SUBJECT: Forwards more detailed response re main steam check valve performance questions arising from NRC Insp 99-05 following completion of assessment being performed by Duke Engineering & Services.

Subject: Response to Questions Related to Main Steam Check Valve Performance per
NRC Inspection 99-05

RESPONSE TO NRC QUESTIONS

FIGURE 1 - SG PRESSURE

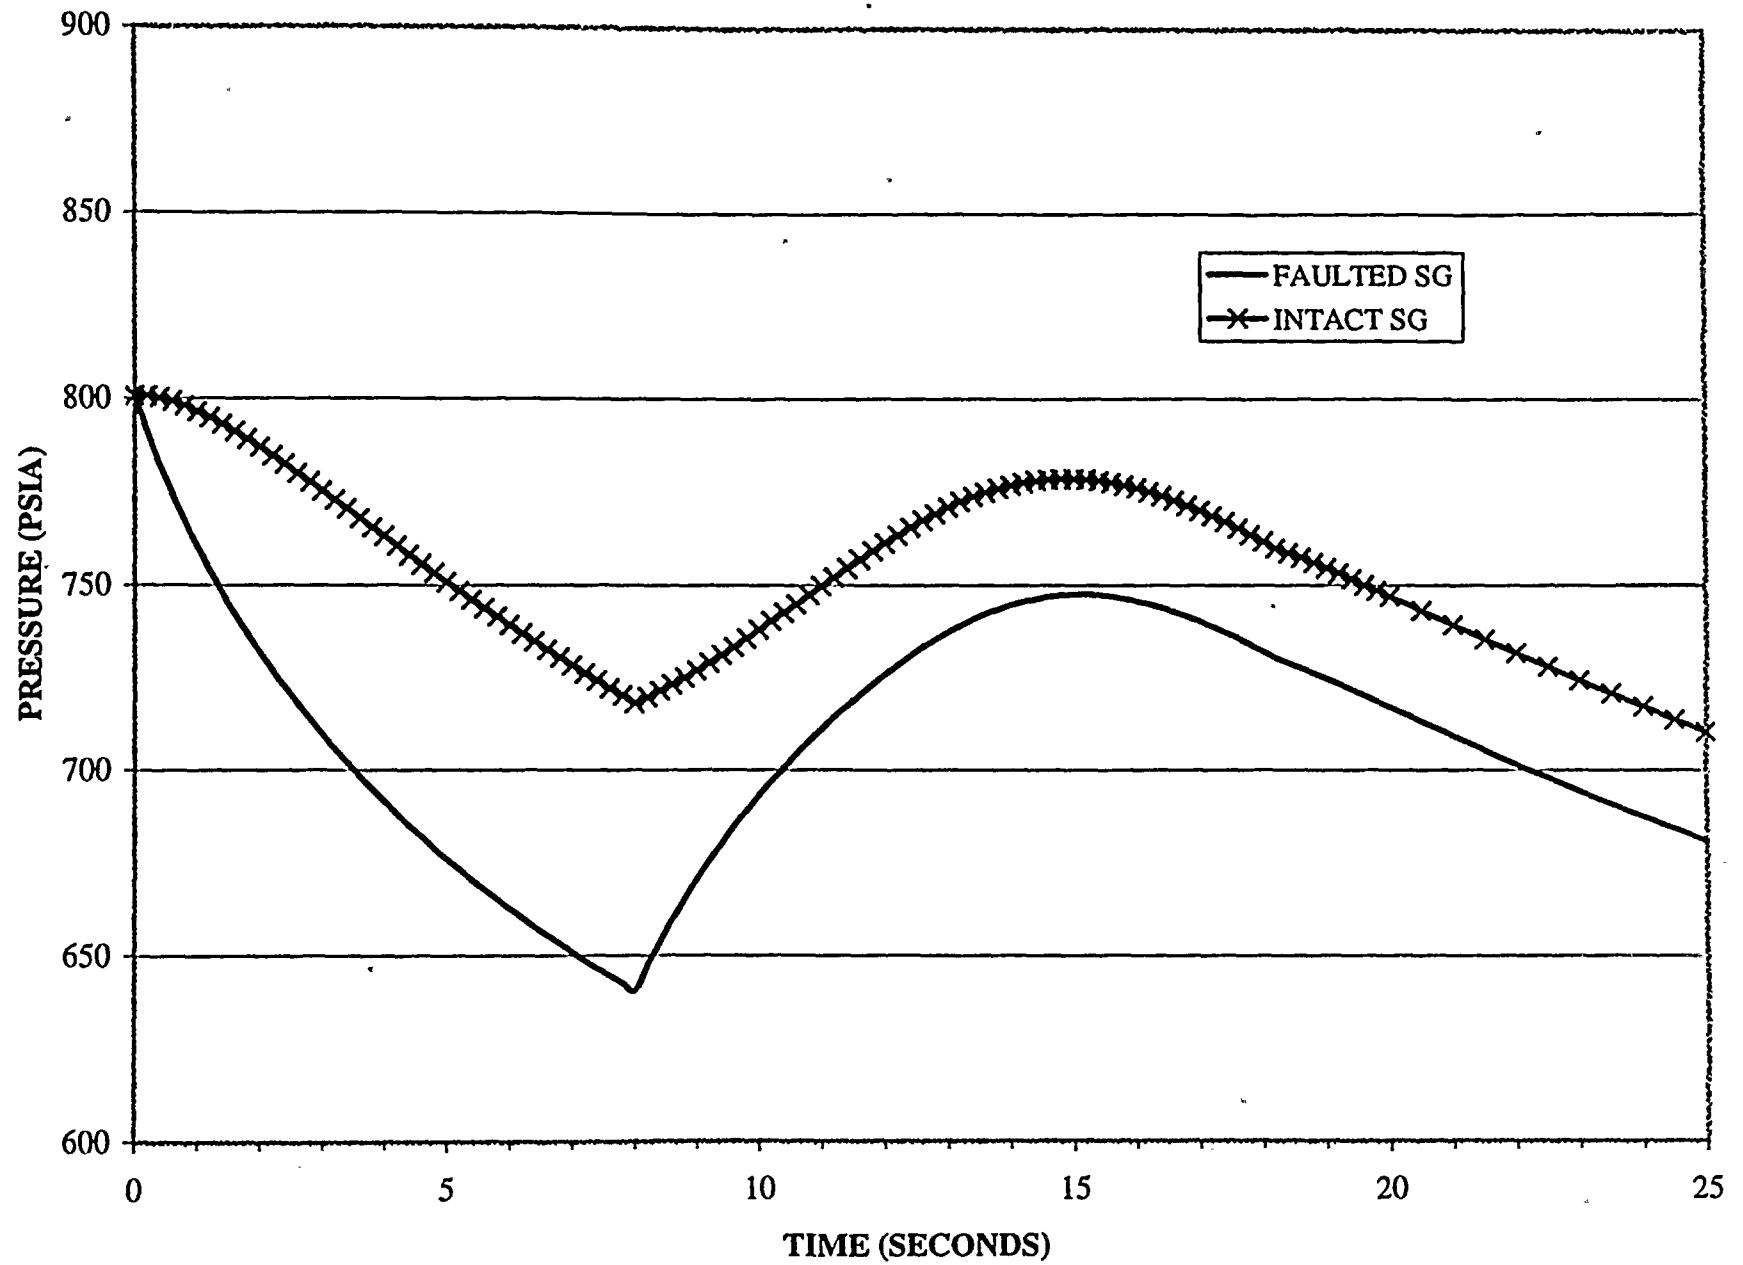
What analysis method will be used? It is felt that a 3-dimensional computational fluid dynamics code is needed to properly model the complex flow conditions. How will the analysis performed be validated for this type of application?

To demonstrate this condition, a revised LOFTRAN analysis was performed in Reference 3 that more closely modeled the reverse flow transient for mass flow from the intact SG to the break location. The Reference 3 analysis also used a more conservative assessment of MS piping hydraulic resistance to minimize reverse flow from the intact SG. The resulting transient SG pressures for the limiting 0.86 ft² steam line break is shown in Figure 1. The resulting transient mass flow rate contribution to the total break flow from each SG is shown on Figure 2.

The Figure 2 results indicate that no reverse flow exists through the MS check valve until after the turbine stop valves have closed. Prior to the closure of the turbine stop valves, all of the break flow is supplied from the faulted SG. After the turbine stop valves have closed, the break area represents the only flow path available for both the faulted and intact SGs. Consequently, reverse flow is initiated from the intact SG to the break location immediately following the isolation of flow to the turbine. The transient flow distribution to the break from the two SGs is a function of the individual SG pressures and the hydraulic resistances for the two flow paths.

Due to the more rapid de-pressurization of the faulted SG prior to the turbine stop valve closure, the intact SG pressure is higher than the faulted SG. This pressure difference causes a surge of flow from the intact SG to the break immediately following the stop valve closure as the difference in SG pressures adjust to the new flow network represented by the closed stop valves and the break. If the initial surge did not close the check valve, the differences in SG pressure would decrease and the flow from the faulted SG would increase while the flow from the intact SG decreases until a new quasi-equilibrium condition exists as shown in Figures 1 and 2.

FIGURE 2 - BREAK FLOW DISTRIBUTION

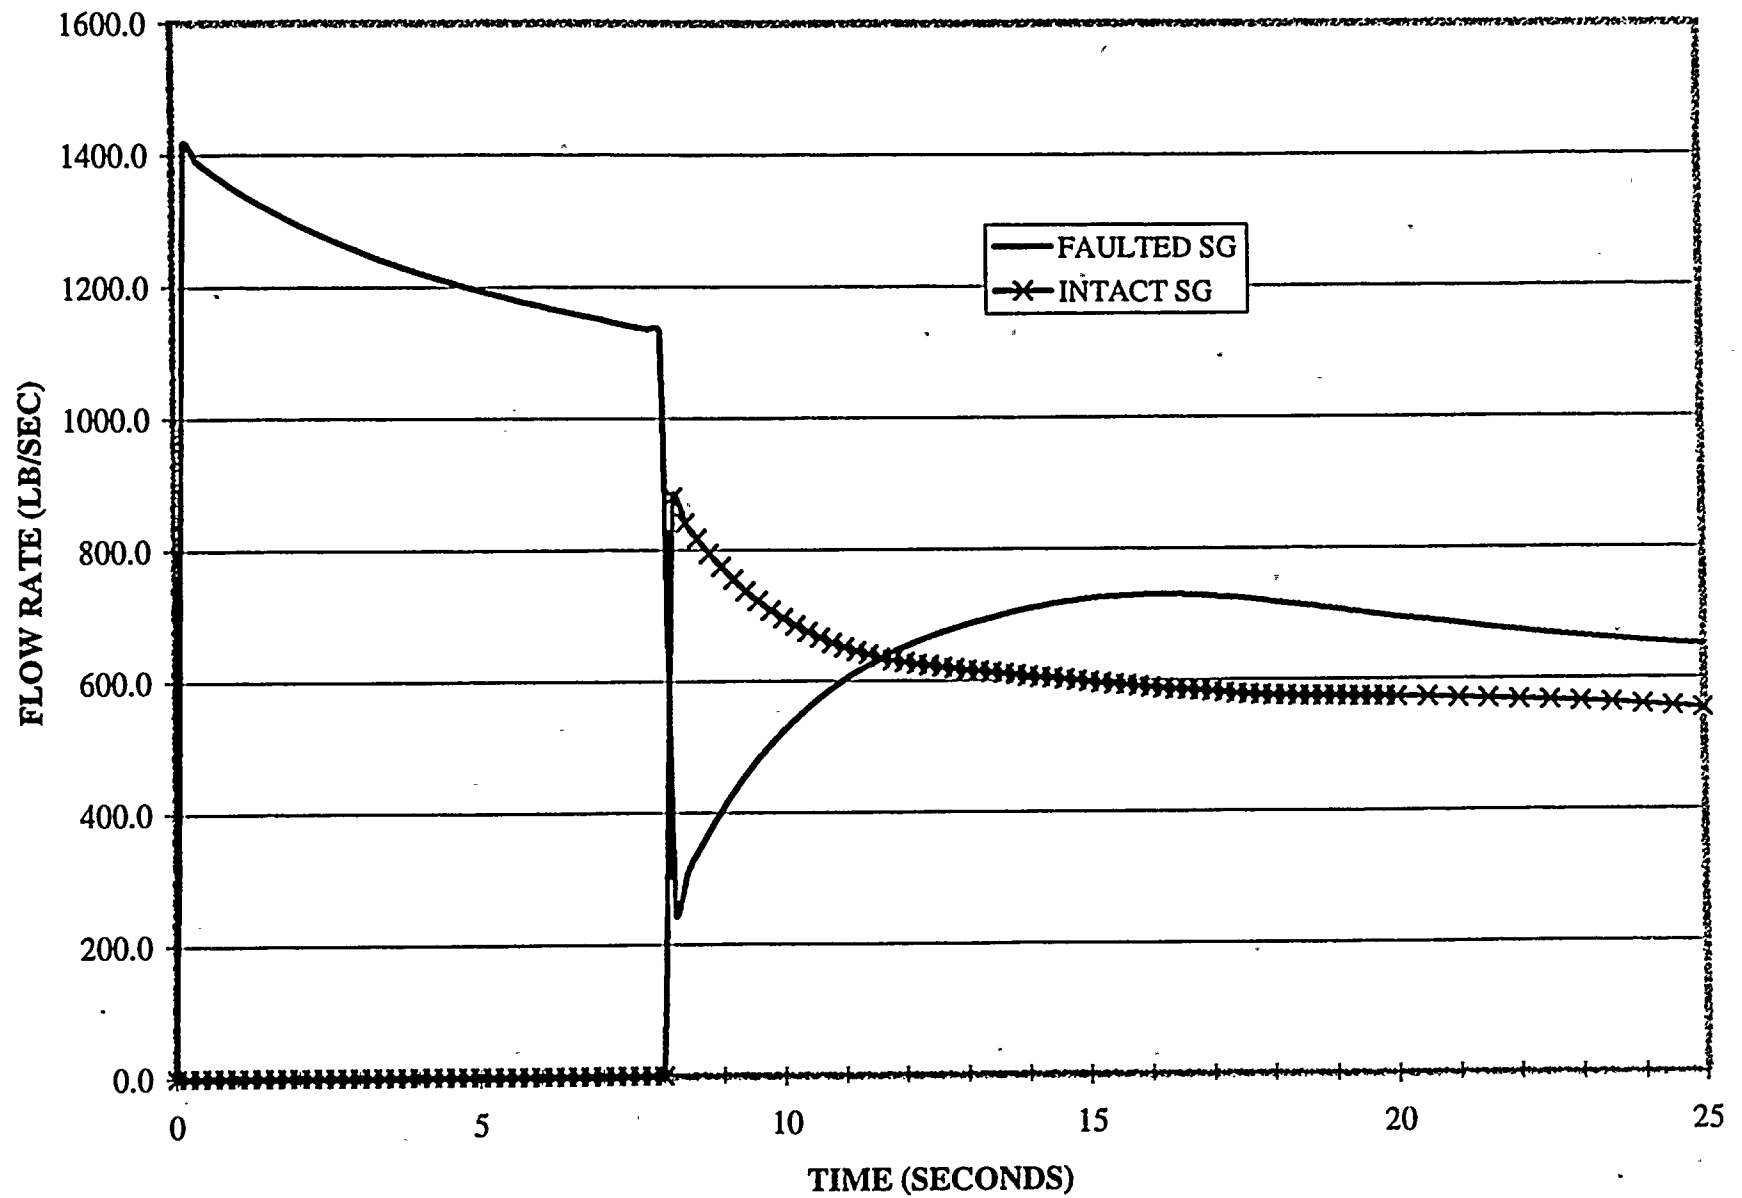
How was the mass flow rate coming from the "line break" SG considered in the calculation of the 603.3 lbm/sec coming from the "operational" Steam Generator?

The maximum reverse check valve flow shown in Figure 2 is approximately 46 % higher than the flow rate used in the Reference 1 analysis. This higher flow indicates that appreciable margin exists with the Reference 1 calculated torque. Using the

Although the DE&S alternate methods calculated lower torques at 603 lb/sec than was used by RG&E in Reference 1; DE&S identified that the torque developed by the actual transient flow shown in Figure 2 resulted in maximum torques well in excess of the 912 ft-lb value calculated by Reference 1. Actual torque margins based upon transient flows ranged from 43 % to 91 % for the two alternate methods. Additionally, DE&S stated that the rapid increase in reverse flow experienced by the check valve would result in a transient impact loading on the valve packing that would cause valve movement at a lower torque than would be developed during normal valve torque testing. Based upon the large flow margin available between the flow used by RG&E in Reference 1 and the actual transient flow shown in Figure 2, DE&S concluded that the fluidynamic forces experienced by the check valve would be sufficient to close the check valves when experiencing the transient flow rates shown on Figure 2.

The flow rate out of the break at any point in time is determined based upon choked flow, the break size and the local steam line pressure at the break location. The break flow is fed by flow that reaches the break from both SGs after the turbine stop valves have closed. Consequently, the break flow represents the summation of the two individual flow paths. The transient flow rates for the two flow paths that supply the break are shown in Figure 2.
